RE: View Point Park, Lot 8, 1020 Nabbs Creek Road, Glen Burnie, MD 21060

Please accept this submittal of a variance for the above referenced project. We are proposing the construction of a single-family dwelling addition on the above referenced lot. The proposed addition is for an elevator shaft as well as a 5' wide bridge/deck for access. The owner is in declining health and is having a difficult time accessing the house. The addition will have a max height of 35'. The addition has an overall footprint of 5' x 5' and is setback 40.89' from the southern rear property line (Nabbs Creek Road right of way), 5' from the western property line, 52.99' from the northern property line, and 40' from the eastern side property line. This proposal will require a zoning variance of 2' to allow the dwelling addition and bridge/deck to be constructed as close as 5' to the side lot line. We will need a variance to disturb slopes greater than 15% within the critical area for this proposal as well.

CONFIRMATION OF PRE-FILE

PRE-FILE #: 2023-0030-P DATE: 10/02/2023

ADMINISTARTIVE SITE PLAN

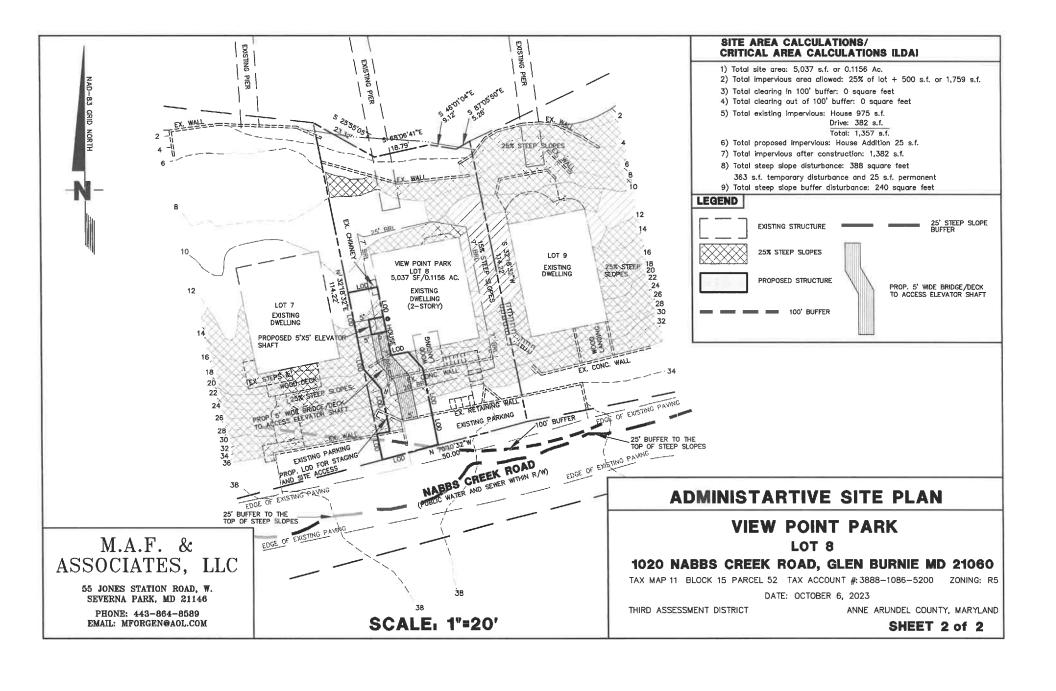
- 1. A variance to allow disturbance to slopes exceeding 15% in the Chesapeake Bay Critical Area (Article 17-8-201).
- 2. A variance to allow less setbacks than required: 7' side required, 5' side proposed.

The applicants are reminded that, in order for the Administrative Hearing Officer to grant approval, the proposal must meet ALL of the Critical Area variance standards provided under Section 18-16-305, which includes the requirement that the variance must be the minimum necessary to afford relief.

- 1. A variance to allow disturbance to slopes exceeding 15% in the Chesapeake Bay Critical Area (Article 17-8-201). Response: Noted
- 2. A variance to allow less setbacks than required: 7' side required, 5' side proposed. Response: Noted The applicants are reminded that, in order for the Administrative Hearing Officer to grant approval, the proposal must meet ALL of the Critical Area variance standards provided under Section 18-16-305, which includes the requirement that the variance must be the minimum necessary to afford relief. Response: Noted
